COMMITTEE OF THE WHOLE SEPTEMBER 2, 2003

SITE DEVELOPMENT FILE DA.01.005
CONCORD STORAGE INC.

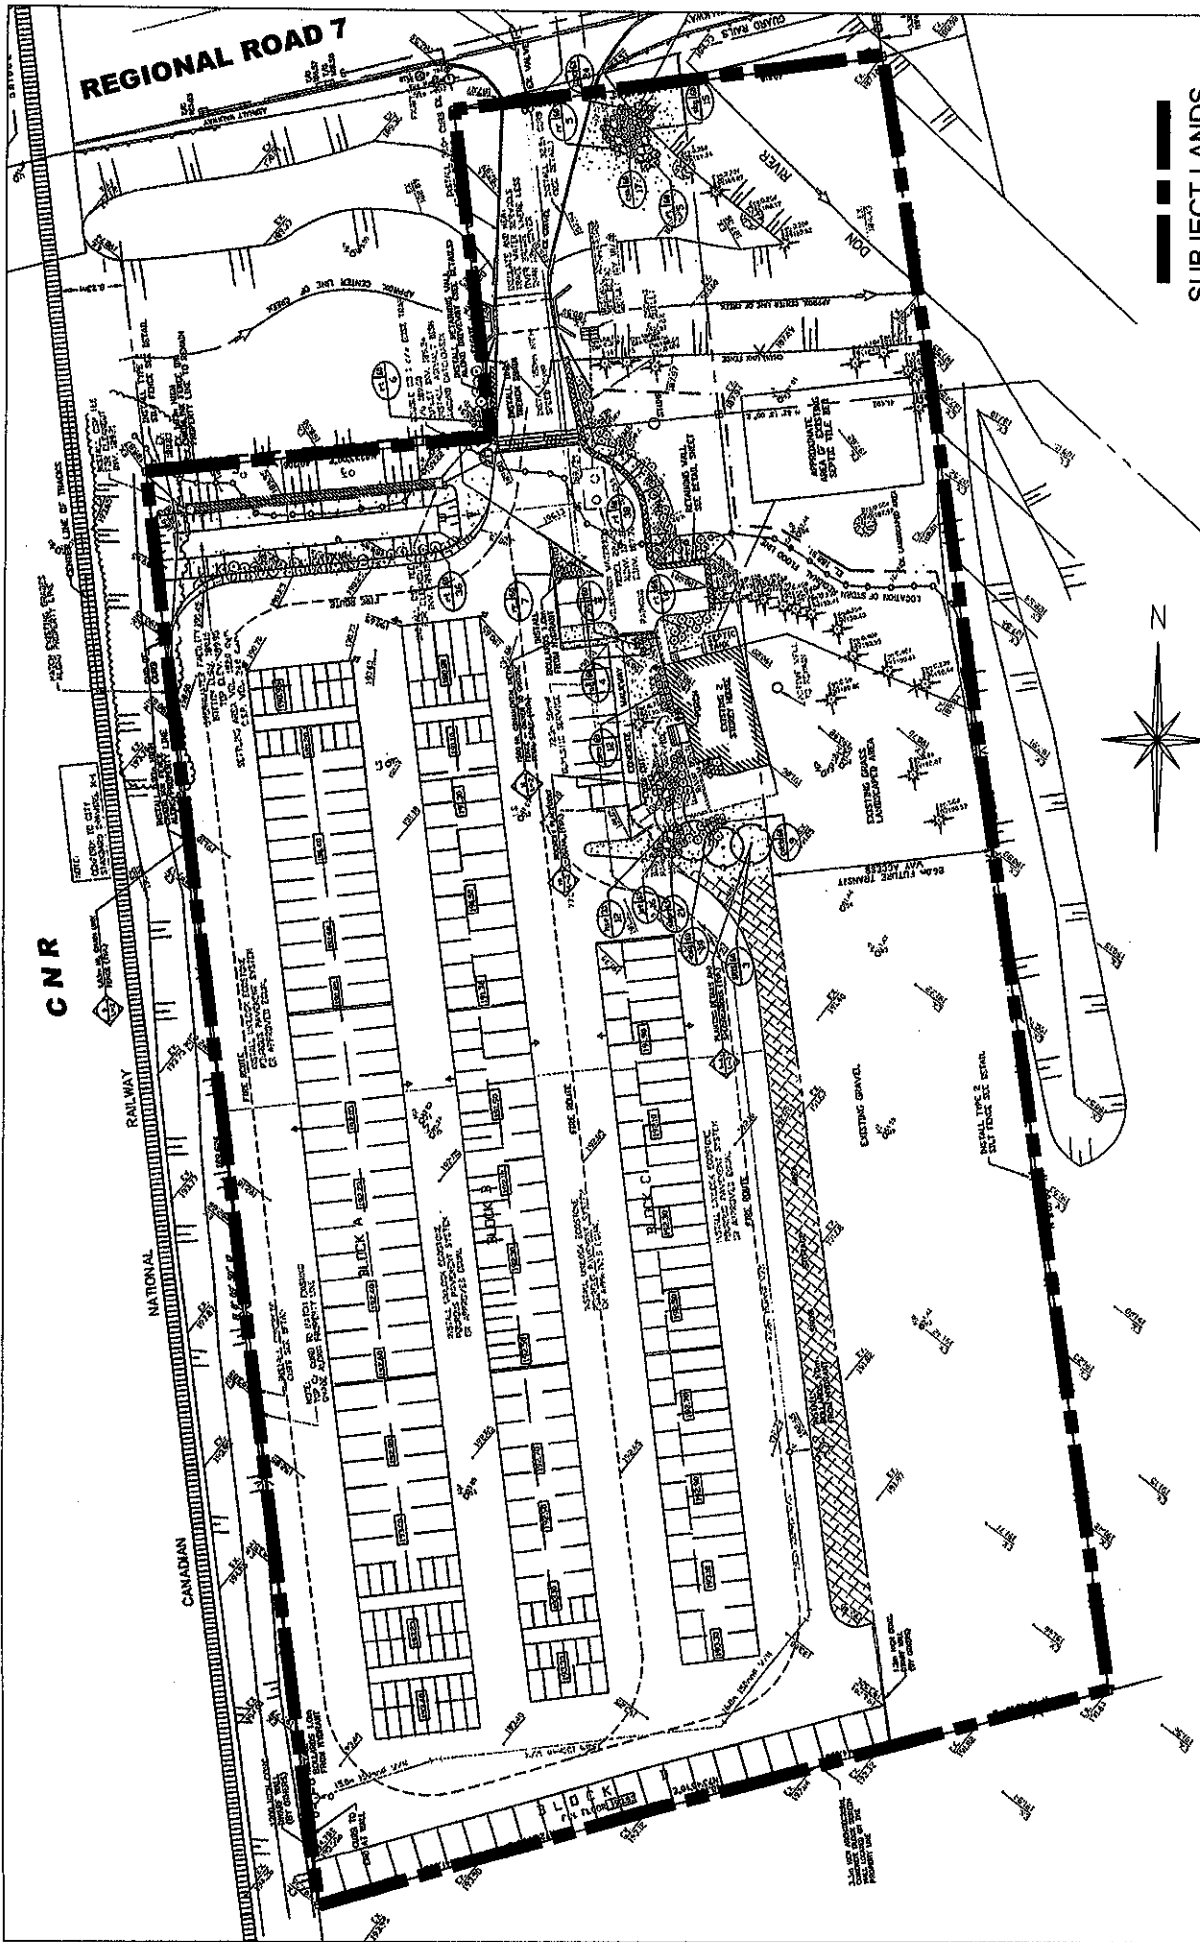
- a driveway, retaining wall and pylon sign within the OS1 Zone is not permitted
- no frontage for the EM1 Zone portion, whereas a minimum 65m is required
- driveway aisles and parking within a portion of the required 7.5m wide landscaped area abutting the OS1 Zone is not permitted
- an unenclosed outside storage area, whereas storage is to be completely enclosed by a wall or fence not less than 2m high
- outside storage in the side yard where the lot has less than 45m frontage, is not permitted
- a minimum 3m rear yard, whereas 12m is required
- a 0m westerly interior side yard, whereas a minimum 6m is required
- 10.7m wide driveway at Regional Road 7, whereas a maximum 7.5m is permitted
- 18m setback from a Residential Zone (across CNR line) to the nearest building, whereas a minimum 20m is required
- 12 parking spaces, whereas 46 are required.

Additional information will be required on the site plan, including parking space dimensions, office floor space clarification, percentage of landscaped area and outside storage area calculations, and setbacks to the OS1 Zone, which will confirm if any further exceptions to the By-law are required.

By-law 1-88 does not have a parking requirement specifically for public storage use. The Building Department advises that a parking requirement of 1 space per 100m² is being applied for the purpose of calculation, which is the minimum requirement used for a "warehousing" use. Public storage would not be expected to generate the parking demand of a warehouse use. Sufficient parking is being provided for the office component, with some surplus for the mini-storage facility. Staff would have no objection to an exception to the parking requirements of the by-law to permit a minimum of 12 spaces for the site.

Landscape Plan
 Part Lot 5,
 Concession 3
 APPLICANT:
 CONCORD STORAGE INC.
 N:\DPT\1 ATTACHMENTS\DA\da.01.005g

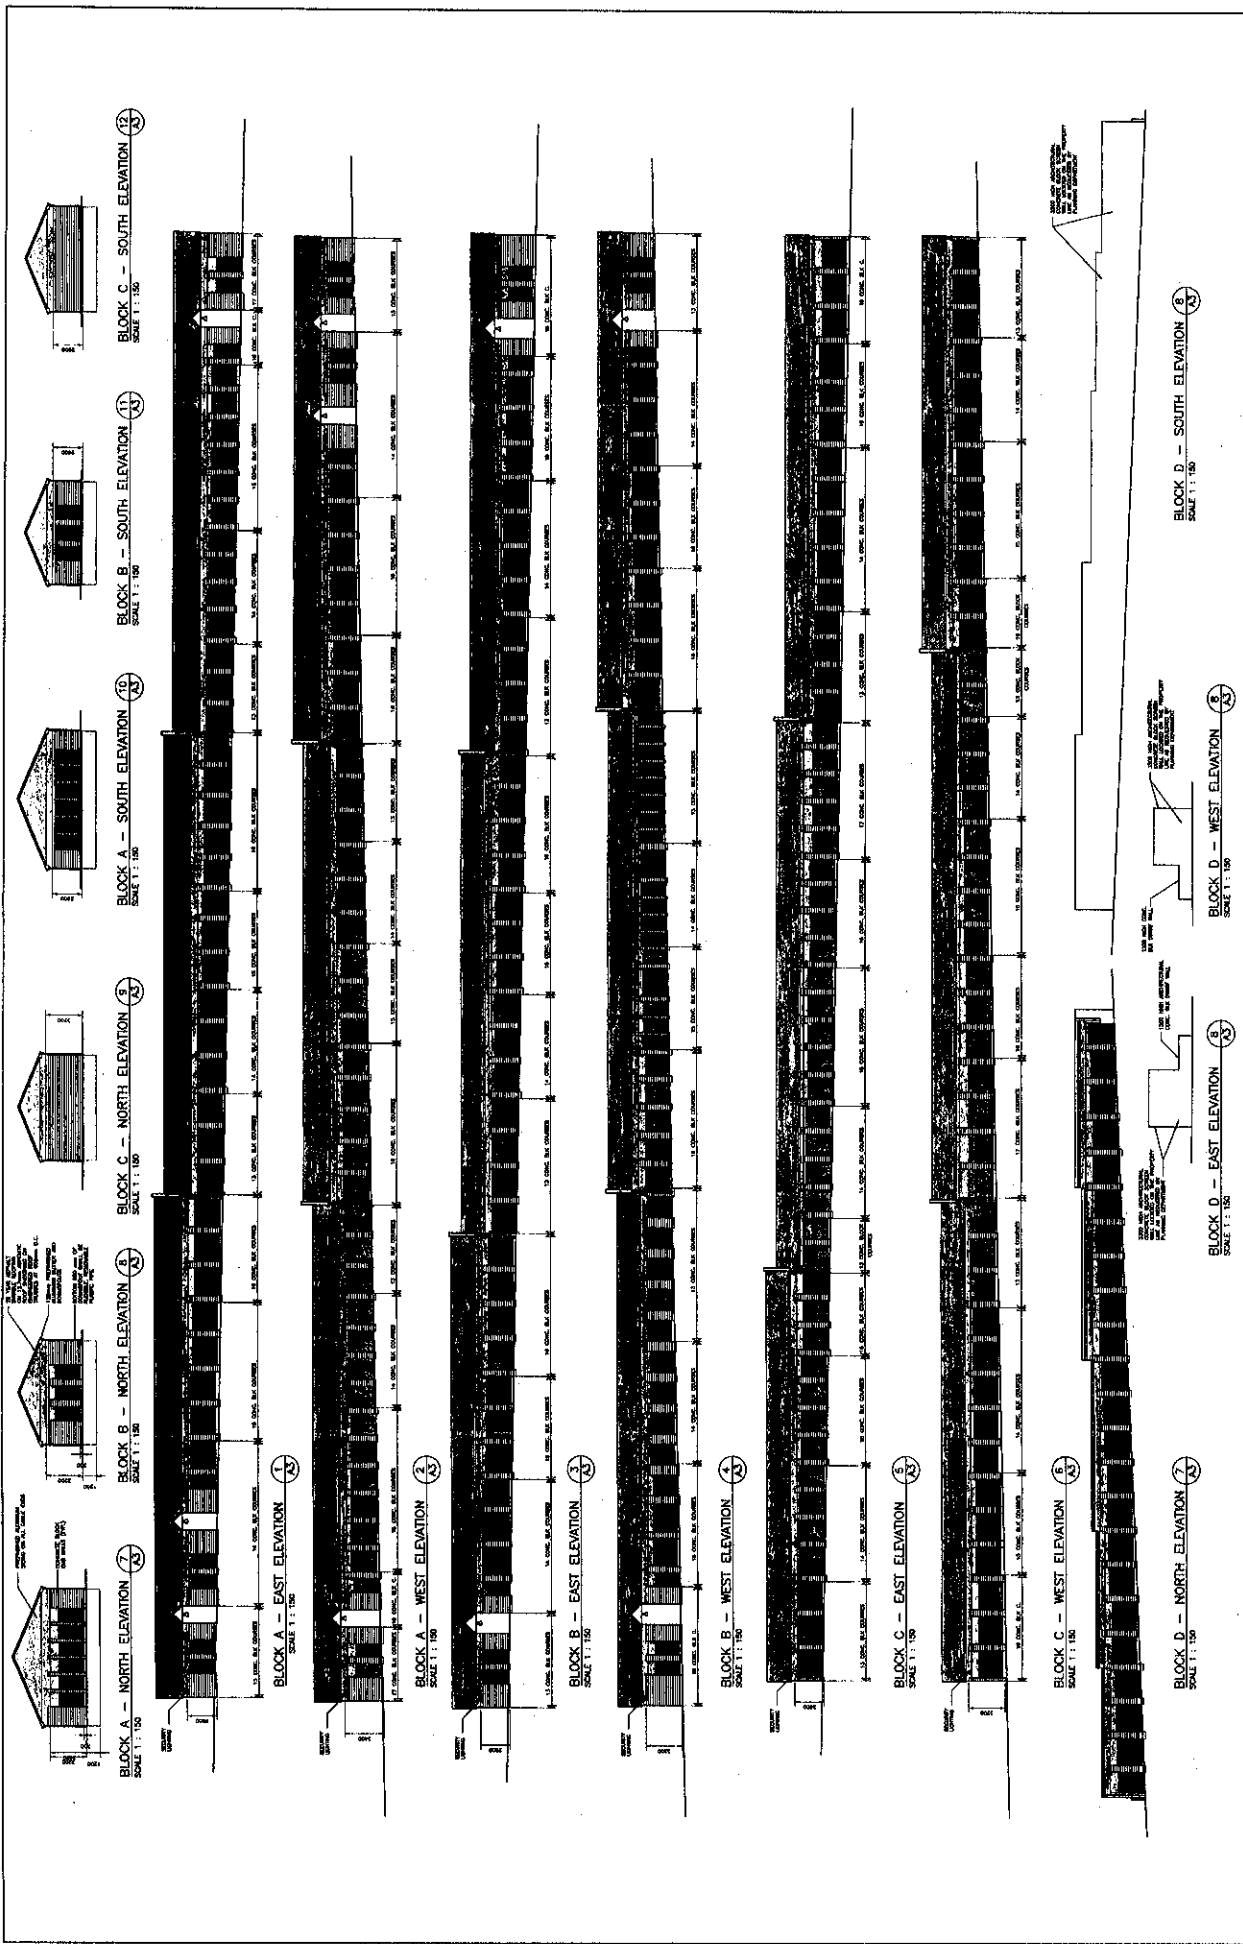
A mix of deciduous and coniferous shrubs and deciduous trees are proposed in the vicinity of the office building and between the storage buildings and Regional Road 7. A walkway is proposed between the parking area and the office building. A pylon sign, together with landscape planting, is proposed on the south side of the driveway at the Regional Road 7 entrance. A retaining wall is proposed on both sides of the driveway leading into the site's parking area. A 1.83 m high chain link fence is proposed along the property line south of the creek. Also, a 18m-chain link fence should be provided along the most southerly line.

Staff recommends that a 3m wide landscape strip be provided along the south lot line, and additional landscaping be provided along the west side of the future transitway right-of-way, as this part of the site will be highly visible to traffic. Also, an 18m high chain link fence should be provided along the most southerly lot line.

The final landscape plan, including detailed drawings and a landscape cost estimate, must be approved by the Urban Design Department.

Elevations

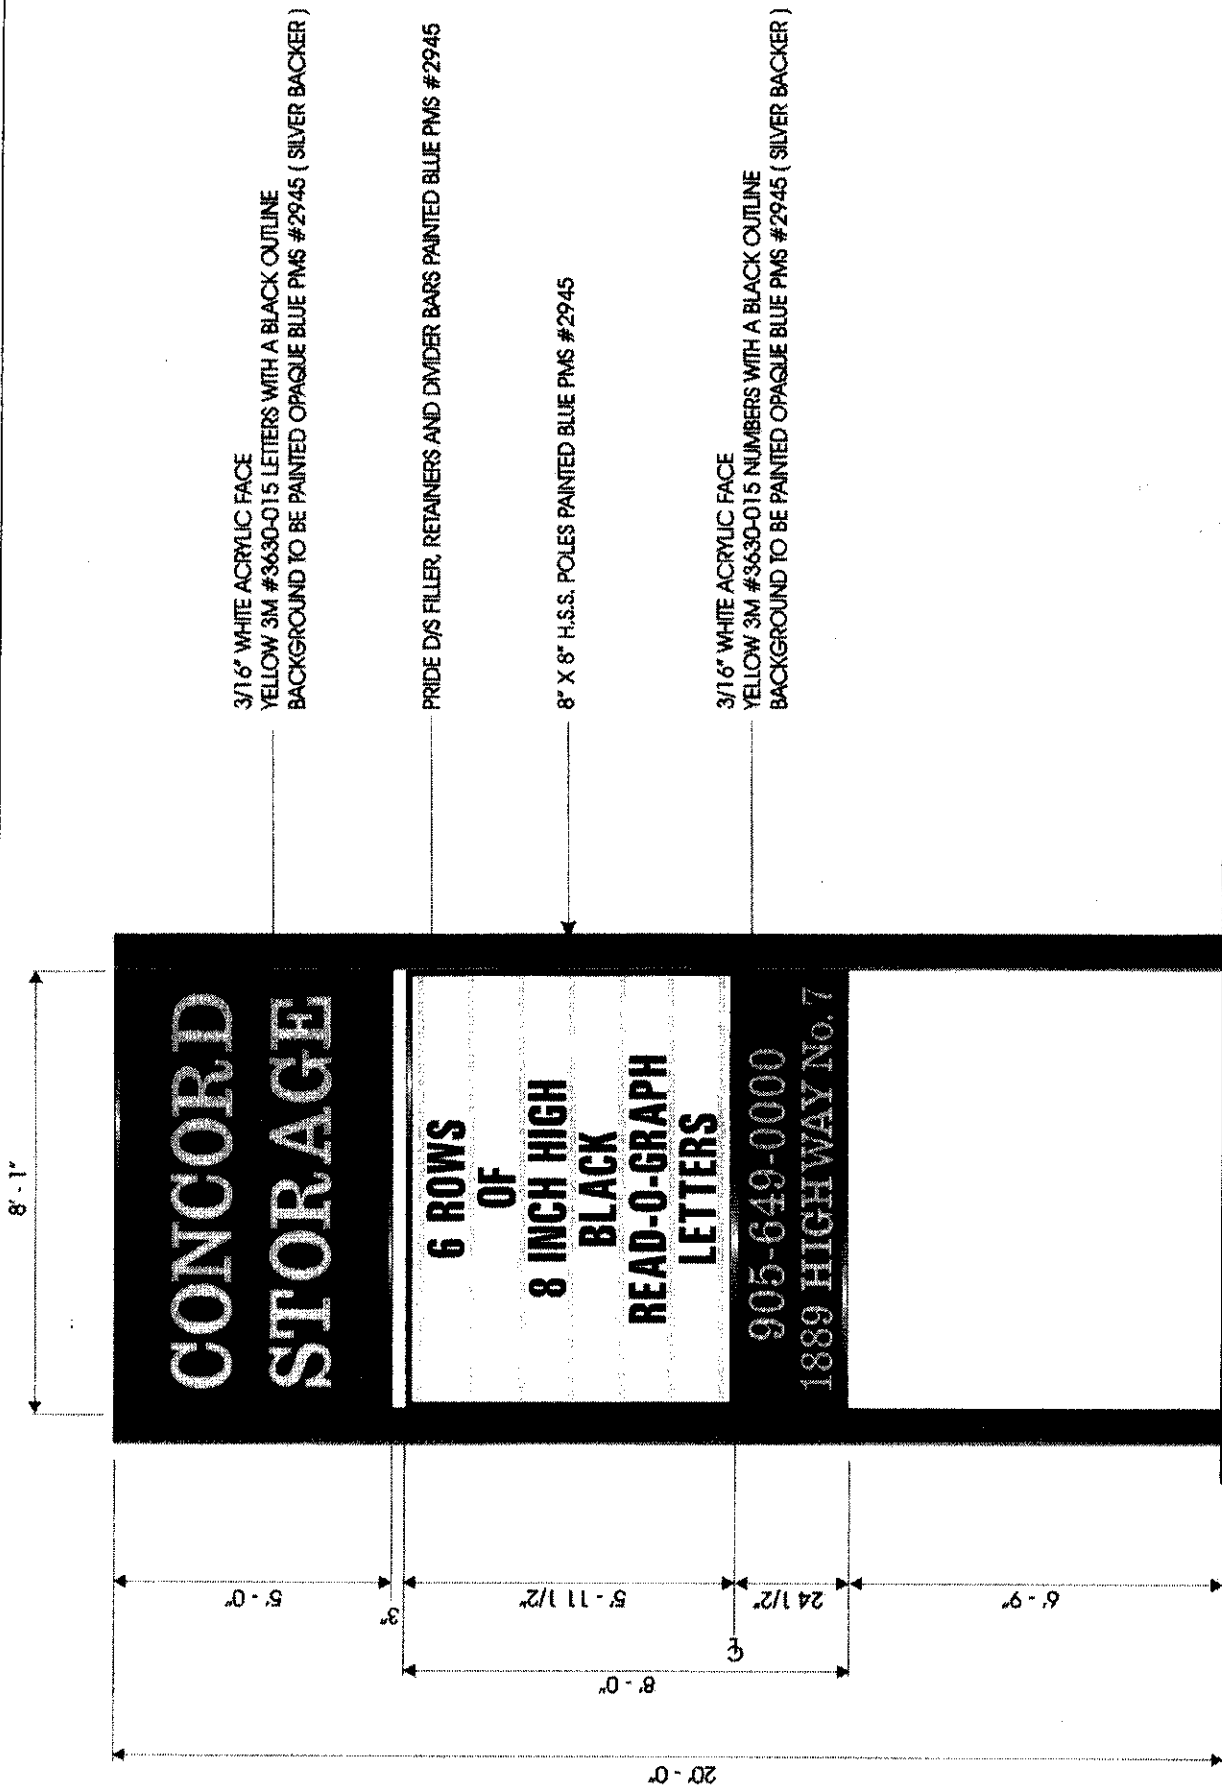
A total of four blocks of mini-storage buildings are proposed on the site. Blocks A, B and C run parallel to each other in a north-south orientation, and Block D runs along the south boundary line of the site. A total of 329 units are proposed. The building materials used include concrete block walls, blue aluminum siding gable ends, a series of blue doors, and blue asphalt shingles. The building walls are approximately 3.2m high. Security lighting is proposed along the entire building wall. No changes are proposed to the existing building to be used for office/storage purposes, however, elevation drawings will be required to be submitted and included in the site plan agreement.

The 3.3m high architectural screen wall is to be removed along the south property line and replaced with the south elevation of Building D, which will be visible from the future transitway station. Instead, Staff recommends that Building D be setback 3m from the lot line, and that additional architectural treatment be incorporated on the south wall. Also, the roof-line should be changed from a flat roof to a gable roof, which is consistent with the other buildings.
